# Service Bulletin

BKSB-1039  
Issue Date 6-16-2014

Issue: Selectable Power Setting Changes

Affected Models: KNG portable (2048 Ch.) and mobile radios upgraded from 4.6.2 to 5.1.0

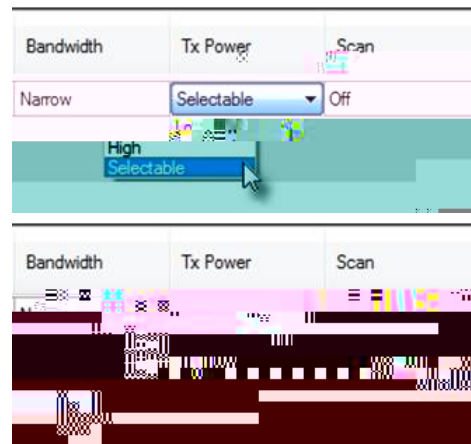
If a channel in a previous firmware version was set to Selectable, then updating the firmware to Ver 5.1.0 will change the 0 whe 0 w00dth e.

are Version 4.6.2  
wer settings

In NeoVision 2.0.3 with Firmware Version 5.1.0 the Mobile Radio has four power settings Low, High, Sel Low and Sel High.

From firmware version 5.1.0 onward, the channel power may be set to any of 4 choices:

**Low:** The radio will always transmit at the power set in the Low Power dropdown list of the Global Conventional window.

**High:** The radio will always transmit at the power set in the High Power dropdown list of the Global Conventional window.

**Sel Low:** By default at reset, the radio will transmit at the power set in the Low Power list. However, you can switch it to High Power with a button, switch, or menu operation.

**Sel High:** This is the converse of Sel Low. By default at reset, the radio will transmit at the power set in the High Power list. Again, you can switch it to Low Power with a button, switch, or menu operation.
